Title - Sujet Heating Plant Decommission & Demoli	
Solicitation No. - N° de l'invitation EJ192-150405/A	Amendment No. - N° modif. 001
Client Reference No. - N° de référence du client 20150405	Date 2014-09-18
GETS Reference No. - N° de référence de SEAG PW-\$\$\$FG-353-65646	
File No. - N° de dossier fg353.EJ192-150405	CCC No./N° CCC - FMS No./N° VME
Solicitation Closes - L'invitation prend fin at - à 02:00 PM on - le 2014-09-30	Time Zone Fuseau horaire Eastern Daylight Saving Time EDT
F.O.B. - F.A.B. Plant-Usine: <input type="checkbox"/> Destination: <input checked="" type="checkbox"/> Other-Autre: <input type="checkbox"/>	
Address Enquiries to: - Adresser toutes questions à: Searchwell, Suzette	Buyer Id - Id de l'acheteur fg353
Telephone No. - N° de téléphone (819) 956-6645 ()	FAX No. - N° de FAX (819) 956-8335
Destination - of Goods, Services, and Construction: Destination - des biens, services et construction: Agriculture Canada Central Experimental Farm 78 Prince of Wales Drive Ottawa, Ontario

ADDENDUM NO. 01

HEATING PLANT DECOMMISSIONING
& DEMOLITION
MISE HORS SERVICE ET DÉMOLITION DE
L'INSTALLATION DE CHAUFFAGE

SK.1

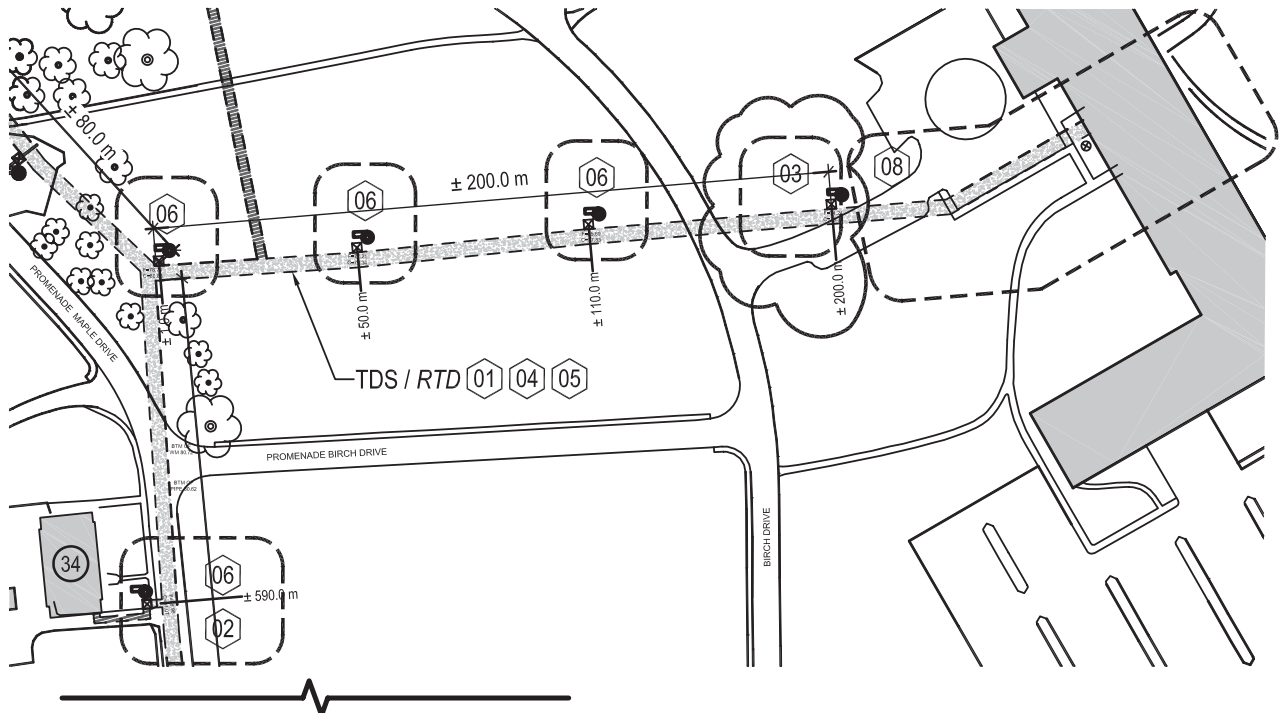
- .2 D-100 Tunnel Distribution System (TDS) Plan
 - .1 Keynote 03 removed from Building 151 (New Barn) and placed at Building 78 (CHP) and at the TDS branch boundary with the SJC project: Replace with sketch SK.1, dated 14/09/09.

AT THE TERMINATION POINTS OF THE SERVICE TUNNEL WITH BUILDINGS, REMOVE THE ACCESS DOORS, PROVIDE FORMWORK AND SEAL THE OPENINGS WITH LEAN CONCRETE. A REINFORCED CONCRETE BULKHEAD (OR APPROVED ALTERNATIVE) TO MEET THE REQUIREMENTS OF THE LIGHTWEIGHT CELLULAR CONCRETE DESIGN SPECIFICATIONS. PROVIDE SHORING AND BRACING AT BASEMENT WALL AND AT FORMWORK AT TDS ENTRANCE UNTIL CONCRETE FILL SETS.

SK.2

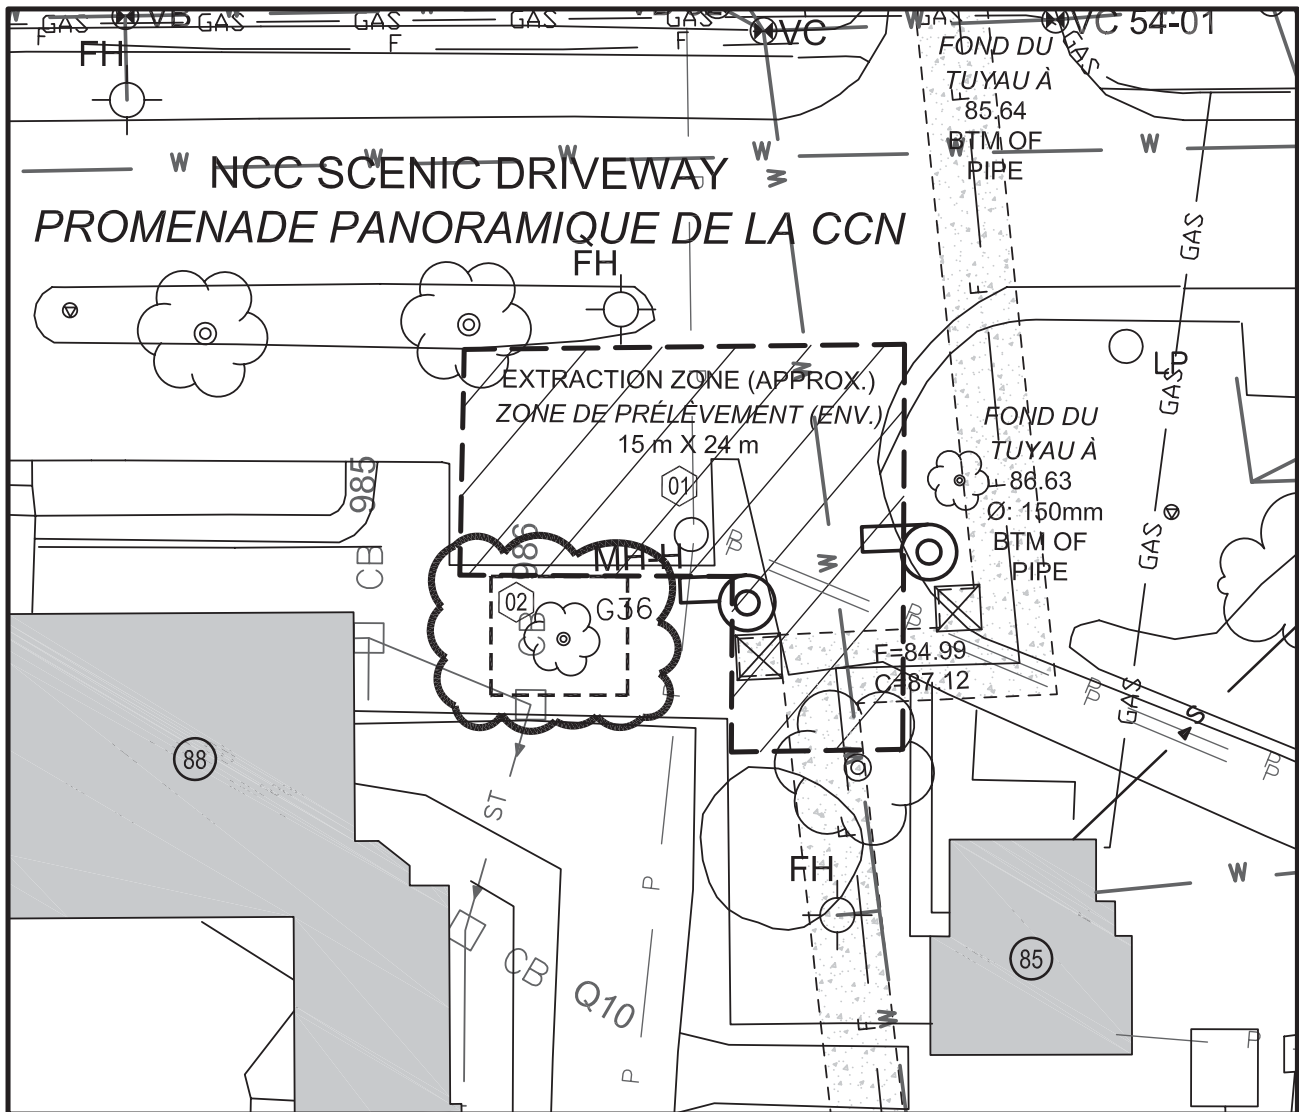
- .3 D-101 Potential Extraction points for TDS
 - .1 Protection of Memorial tree near Building 88 (Canada Agriculture and Food Museum Dairy Barn) and NCC Scenic Driveway, no work within drip-line: Replace with sketch SK.2, dated, 14/09/09.

TREE PROTECTION AREA: PROTECT TREE TO DRIP LINE FROM DAMAGE.
